PRODUCT/PROCESS CHANGE NOTIFICATION

PCN MMS-MIC/14/8390
Dated 07 May 2014

**STM8 & STM32 products in LQFP 14x14 & 20x20 packages -
Transfer assembly & test sites from Amkor ATK (Korea)
to Amkor ATP (Philippines)**

What are the changes?

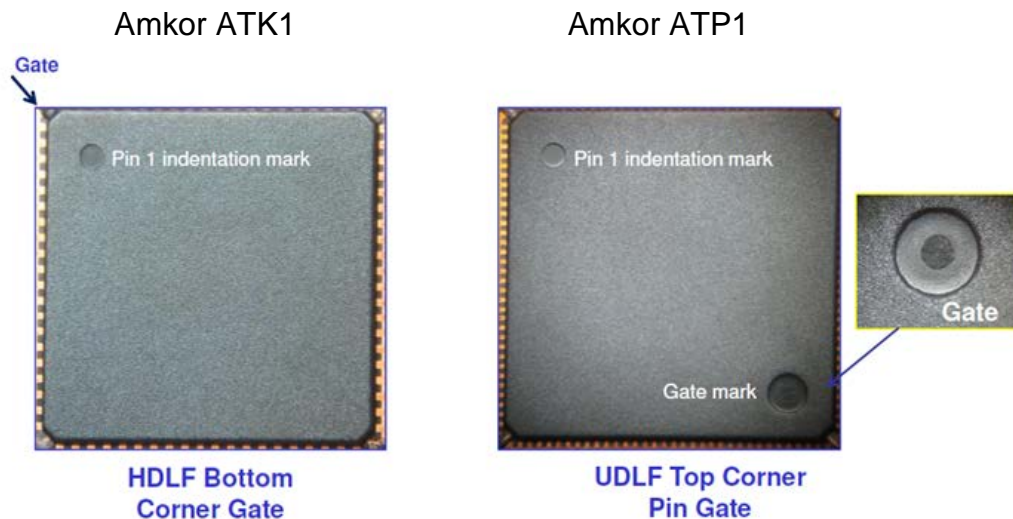
New Bill Of Material is described below:

Previous	New
Assembly site	Amkor ATK1 (Korea)	Amkor ATP1 (Philippines)
Test site	Amkor ATK3 (Korea)	Amkor ATP3 (Philippines)
Mold compound	Nitto GE7470LQ	Sumitomo G631HQ
Glue	Ablestik 8200C	Sumitomo CRM1076YB
Leadframe	High Density Lead Frame (HDLF)	Ultra high Density Lead Frame (UDLF)

Gate mark on Ultra high Density Lead Frame:

An additional gate mark is visible on top of the package, in addition to pin 1 identification mark.

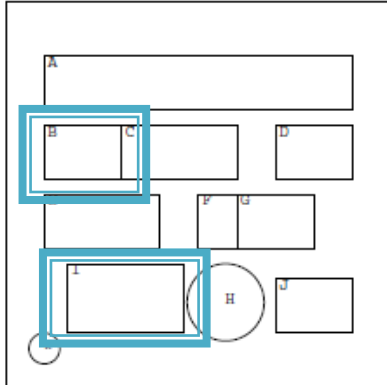
This change will be qualified using the standard STMicroelectronics Corporate Procedures for Quality and Reliability, in full compliancy with the JESD-47 international standard. You can find below Qualification Plan.
